Subject: FUSES REMOVED AT THE FACTORY HAVE CHANGED	Service Alert No.: SA-024/21
	Last Issued : 03/25/2021

2021 CX-5 vehicles with 10.25" center display

(1) Relay and Fuse block

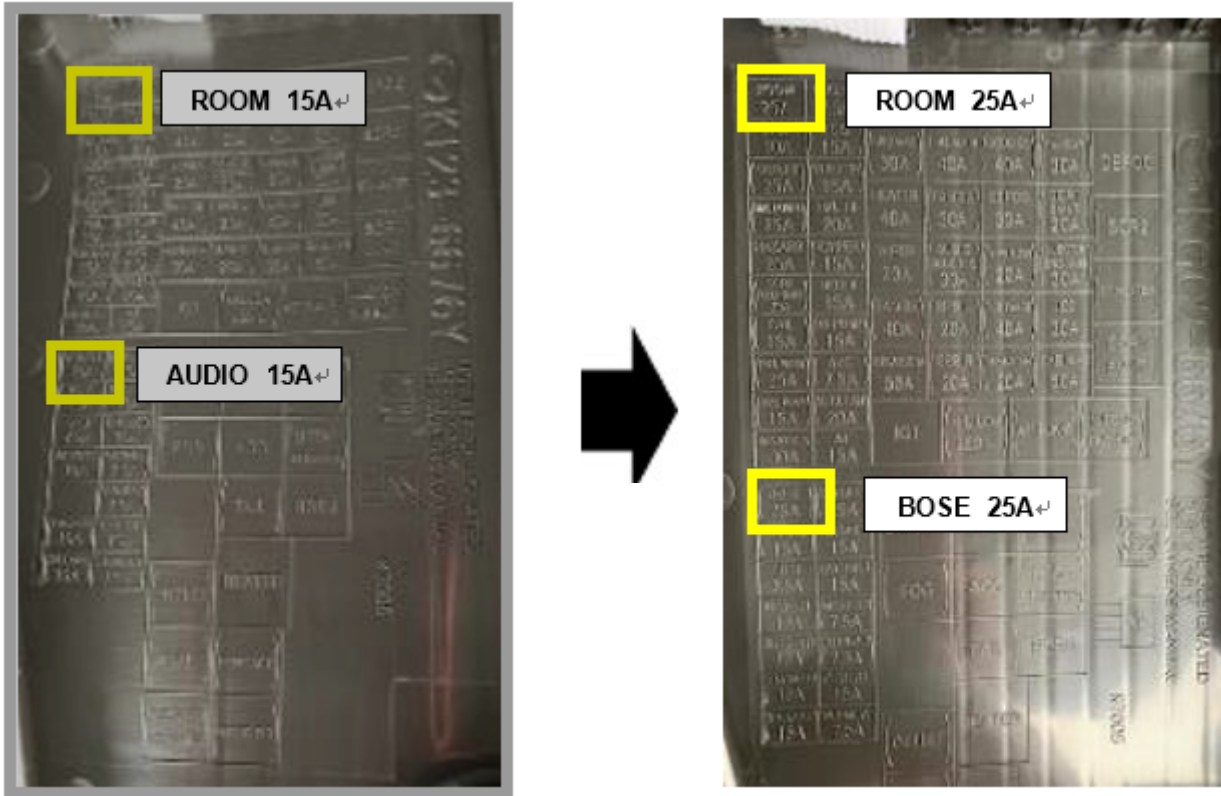
Be aware that the fuses removed at the factory have been changed.

The fuses removed from the relay and fuse block (1) are as follows:

- **Previous** Room (15A), Audio1 (15A)
- **New** Room (25A), BOSE (25A)

NOTE: The new BOSE fuse is in the same location as the previous Audio1 fuse.

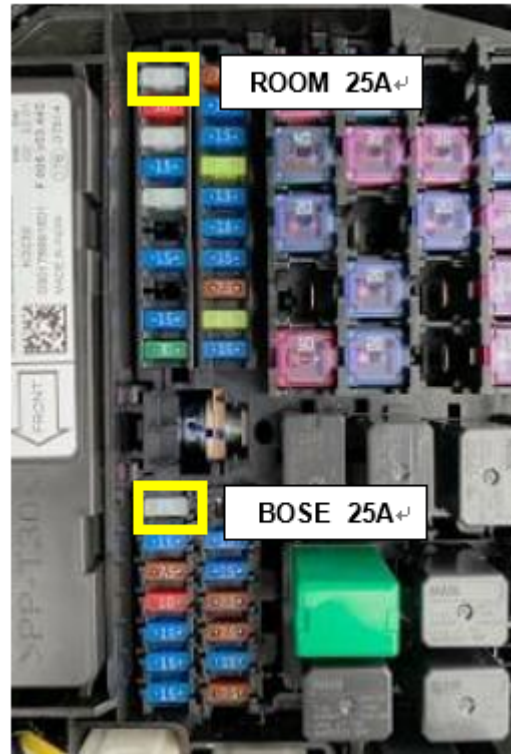
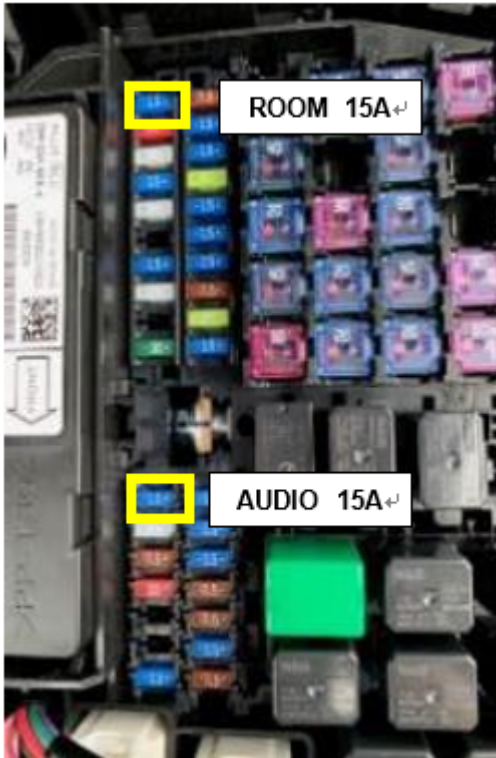
Previous CX-5

Insert 15A fuses in the ROOM / AUDIO locations.

CX-5 Vehicles with 10.25" center display

Insert 25A fuses in the ROOM / BOSE locations.
NOTE: Without the BOSE fuse inserted, MAZDA CONNECT will not operate.
